Product Change Notification

PCN-MI-529-2017

Part #	Type Description
1202577	E/UK-NS 35

Description for Product Change Notification

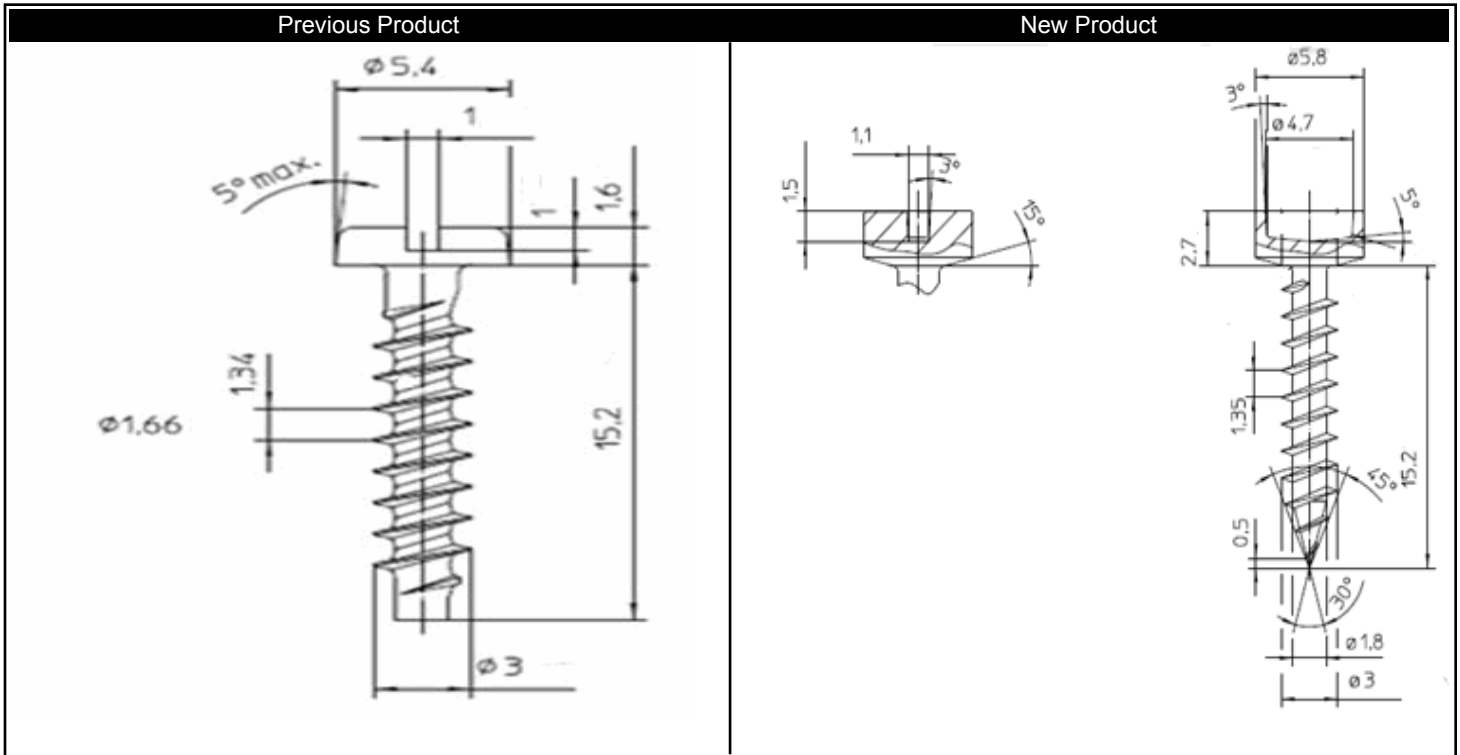
The current screw has been discontinued by the supplier. Therefore, we had to qualify another screw for this item. The new screw is the same as in E/UK [1201442]. The drilling depths and diameters within the housing have been adjusted to the new screw – these adjustments are not visible.
